Response to the Reviewers' Comments

The authors would like to thank the reviewers for the precious comments and suggestions on the technical contents and presentation of our manuscript “Runtime Power Management of Battery Electric Vehicles for Extended Range with Consideration of Driving Time,” submitted to IEEE Transactions on Very Large Scale Integration (TVLSI.) This revised manuscript has been greatly improved thanks to the reviewers’ invaluable advices. We have revised the manuscript faithfully following the reviewers’s comments. We include the newly added or significantly modified parts in the revised version of the paper also in Response to Reviewers. We highlight the important technical content changes and set those parts in a red color in the revised paper.

Fig. 2: (a) Range-speed experimental data for Chevrolet Bolt [36] and (b) comparison with simulation results of the proposed EV power model.

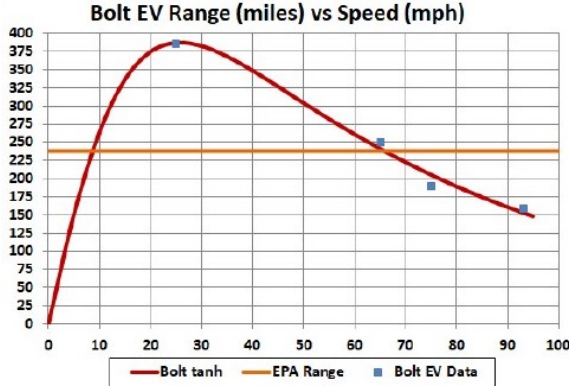
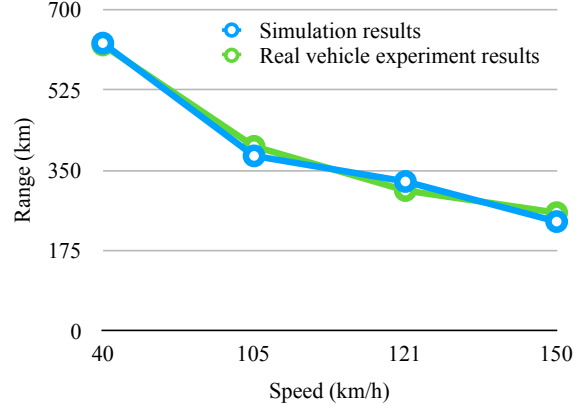
R1-C2 It is not clear how to validate the power model of EV. As the author mentions that accuracy of power model is quite important, it is good to see the power model in this paper can be validated by some real measurement results.

We further evaluate the model accuracy with the range-speed real vehicle experiments as shown in Fig. 2(a) to confirm the derived power models are close enough to the real vehicle measurement data [32], [33], [34], [35], [36]. We refine the coefficients until all the available data values match well.

As a result, the derived EV power model well matches with the range-speed experimental data as shown in Fig. 2(b) as well as the top speed and maximum acceleration setting the aerodynamic resistance, rolling resistance, curb weight, etc. with the known values. The errors in the range-speed simulation is merely 1.4%, the time for 0-to-100 km/h error is 7.8%, and the top speed error is 3.0%, respectively. We revised the manuscript adding the following paragraph with a new figure in Section III.A on page 3 and 4.

We further evaluate the model accuracy with the range-speed real vehicle experiments as shown in Fig. 2(a) to confirm the derived power models are close enough to the real vehicle measurement data [32], [33], [34], [35], [36]. We refine the coefficients until all the available data values match well.

As a result, the derived EV power model well matches with the range-speed experimental data as shown in Fig. 2(b) as well as the top speed and maximum acceleration setting the aerodynamic resistance, rolling resistance, curb weight, etc. with the known values. The errors in the range-speed simulation is merely 1.4%, the time for 0-to-100 km/h error is 7.8%, and the top speed error is 3.0%, respectively.

Fig. 13: Comparison of EDP for the proposed energy-aware-velocity planning methods.

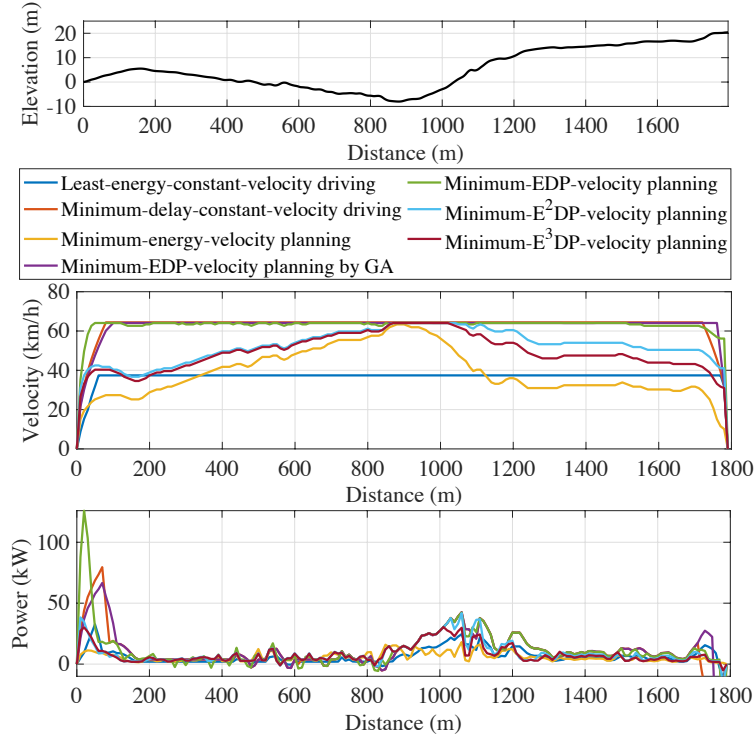
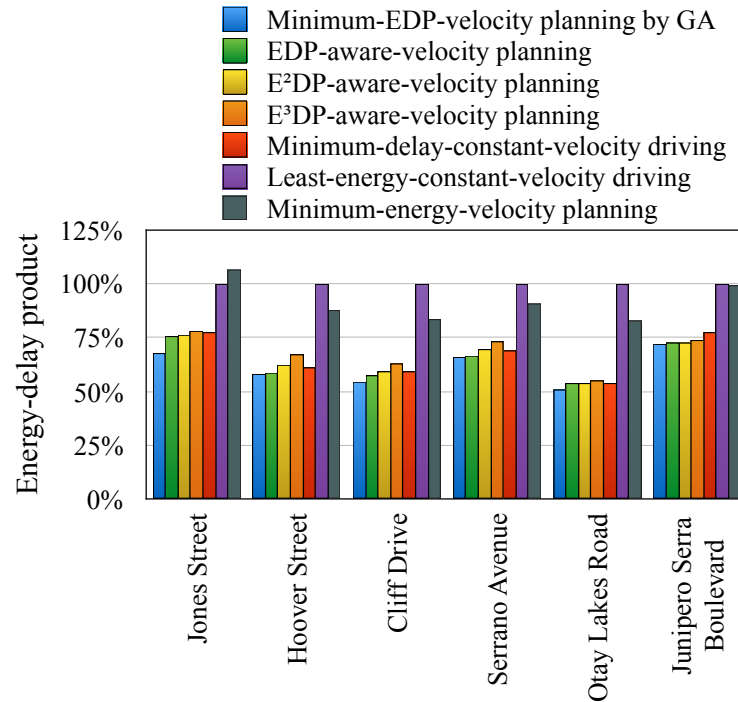
R1-C3 The optimality of the proposed scheduling algorithm is unclear. The author should add several paragraphs to discuss this topic. It is also to see the comparison baseline is well accepted to show the advantage of the proposed algorithm.

EDP of the proposed EDP-aware-velocity planning is merely 4.3% higher than that of the results of GA on average. Through this results, we confirm that the results of the proposed heuristics are close enough to the true optimal solutions.

Fig. 13 summarizes EDP of the least-energy-constant-velocity driving, the minimum-delay-constant-velocity driving, the minimum-energy-velocity planning, the velocity planning with EDP , E^2DP and E^3DP as a metric on the road benchmarks and the minimum-EDP-velocity planning with GA. The proposed velocity planning results in up to 46.2% improvements of EDP compared with the least-energy-constant-velocity driving. The driving velocity on a flat road is faster than that of the least-energy-constant-velocity driving at the expense of relatively little energy to save driving time. Then, the velocity decreases when climbing the following uphill to spend less motor torque, which saves more energy.

In addition, EDP of the proposed EDP-aware-velocity planning is merely 4.3% higher than that of the true EDP-minimum-velocity planning on average. Through this results, we confirm that the results of the proposed heuristics are close enough to the true optimal solutions.

We also updated Fig. 12 and Fig. 13:

Fig. 11: Histograms of velocity and acceleration for the proposed energy-aware-velocity planning methods without an acceleration constraint (a) and (b) and with an acceleration constraint (c) and (d), respectively.

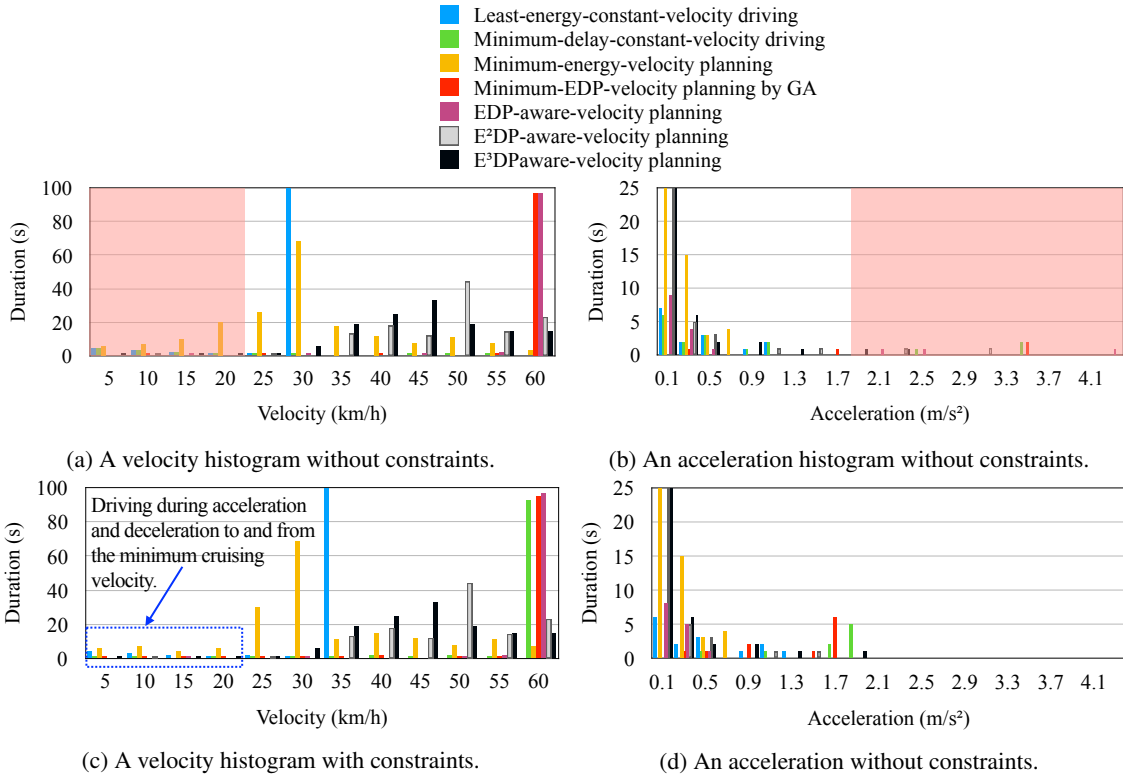
R2-C2 It would be good to have more discussion on the assumptions of the approach and the experiments, e.g., how much can the velocity be changed in practical scenarios without impeding traffic and causing unsafe situations (also depending on the road conditions and whether it is urban or rural environment I suppose). Currently, there only seems to be one constraint on not slower than 10 km/h.

We quantize the velocity and acceleration values and make a histogram to analyze population of velocity and acceleration for the proposed energy-aware-velocity planning methods. Fig. 11(a) and (b) show two histograms of the driving schemes in Fig. 12, which do not have velocity and acceleration constraints. We avoid a cruising velocity lower than 25 km/h and an acceleration higher than 2.0 m/s^2 in this paper without loss of generality. The acceleration of 2.0 m/s^2 is the same as the maximum acceleration of compact cars designed to be used primarily used in urban areas (13 seconds of 0-to-100 km/h time).

Fig. 11(c) and (d) shows the velocity and acceleration histograms with the constraints. Once we run the DP for the first time without constraints, we analyze the histogram, adaptively determine the minimum cruising velocity and maximum acceleration constraints, and run DP again. We keep the same constraints for online recomputation whenever unexpected interrupts occurs.

We quantize the velocity and acceleration values and make a histogram to analyze population of velocity and acceleration for the proposed energy-aware-velocity planning methods. Fig. 11(a) and (b) show two histograms of the driving schemes in Fig. 12, which do not have velocity and acceleration constraints. We avoid a cruising

velocity lower than 25 km/h and an acceleration higher than 2.0 m/s^2 in this paper without loss of generality. The acceleration of 2.0 m/s^2 is the same as the maximum acceleration of compact cars designed to be used primarily used in urban areas (13 seconds of 0-to-100 km/h time).

Fig. 11(c) and (d) shows the velocity and acceleration histograms with the constraints. Once we run the DP for the first time without constraints, we analyze the histogram, adaptively determine the minimum cruising velocity and maximum acceleration constraints, and run DP again. We keep the same constraints for online recomputation whenever unexpected interrupts occurs.

Fig. 8: Altitude changes in the real road benchmarks.

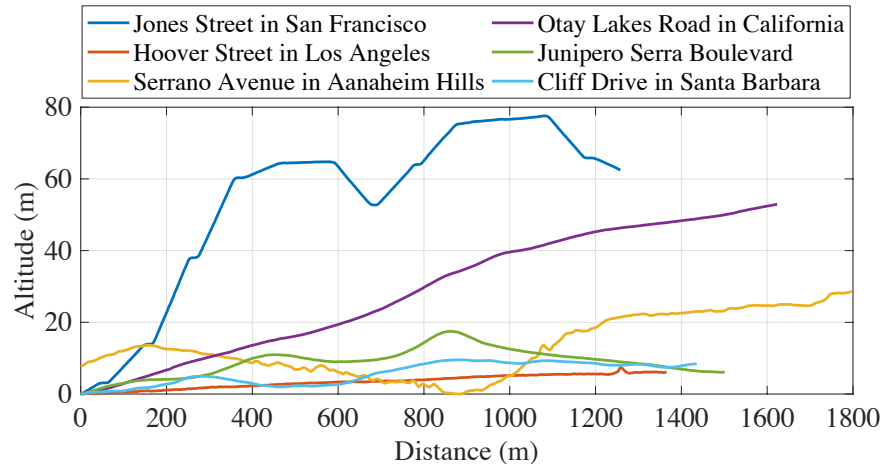
R2-C3 Related to the last point, it would be good to have more discussion on the road benchmarks, e.g., how they are generated and how representative they are. The optimization results significantly depend on road slope. It would be good to use a variety of real road segments for testing.

R2-A3 We appreciate the reviewer's comment. We replaced the previous synthetic road benchmarks with the real road benchmarks. We made six new real road benchmarks from various locations in California. The first three roads are in cities. Jones Street in San Francisco and Hoover Street in Los Angeles are two representative city landscapes such as hills and flat roads, respectively, and Cliff Drive in Santa Barbara is a mixture of those. The second two roads are in mountain areas: Serrano Avenue in Anaheim Hills and Otay Lakes Road in San Ysidro Mountain in California. The last road is Junipero Serra Boulevard connecting San Francisco and San Jose. The details of road data is summarized in Table II, and Fig. 8, which visualize the altitudes of the road benchmarks. We also revised all the associated contents with the new real road benchmarks.

We choose six roads from various locations in California and make real road benchmarks. The first three roads are in cities. Jones Street in San Francisco and Hoover Street in Los Angeles are two representative city landscapes such as hills and flat roads, respectively, and Cliff Drive in Santa Barbara is a mixture of those. The second two roads are in mountain areas: Serrano Avenue in Anaheim Hills and Otay Lakes Road in San Ysidro Mountain in California. The last road is Junipero Serra Boulevard connecting San Francisco and San Jose. The details of road data is summarized in Table II, and Fig. 8, which visualize the altitudes of the road benchmarks.
